PAVEMENT DESIGN REPORT

Copper Chase at Sterling Ranch, Filing No. 1 Phase 1 El Paso County, Colorado

V1_Pavement Report Comments.pdf Markup Summary

Urban Local Roads Nomograph

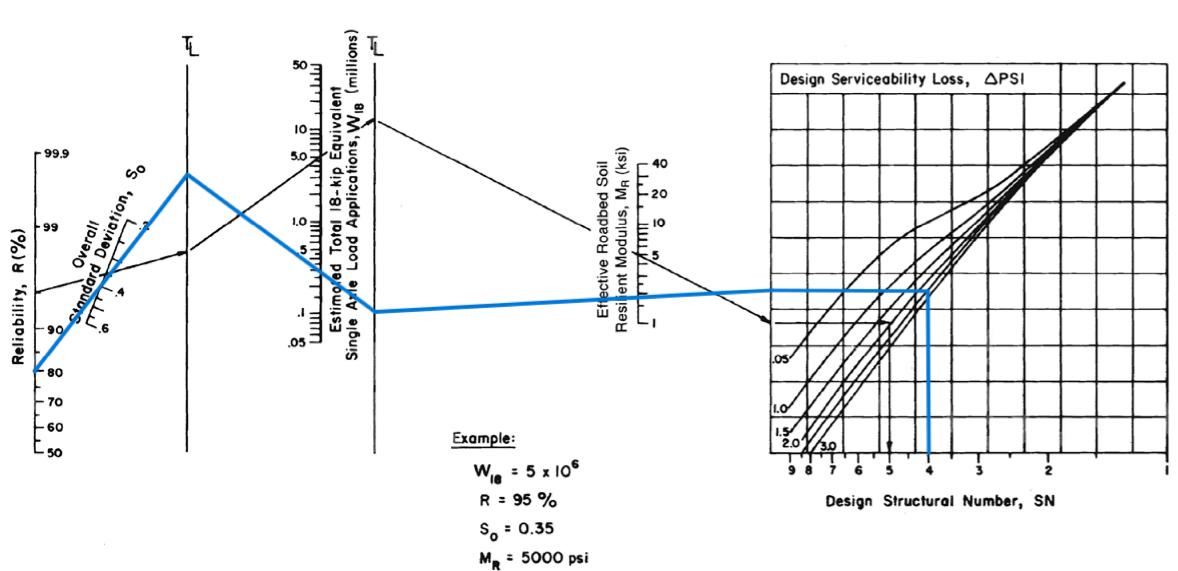
The pavement design nomograph should be for the design provided. Please provide a nomograph for the proposed design per ECM Appendix D.6 criteria.
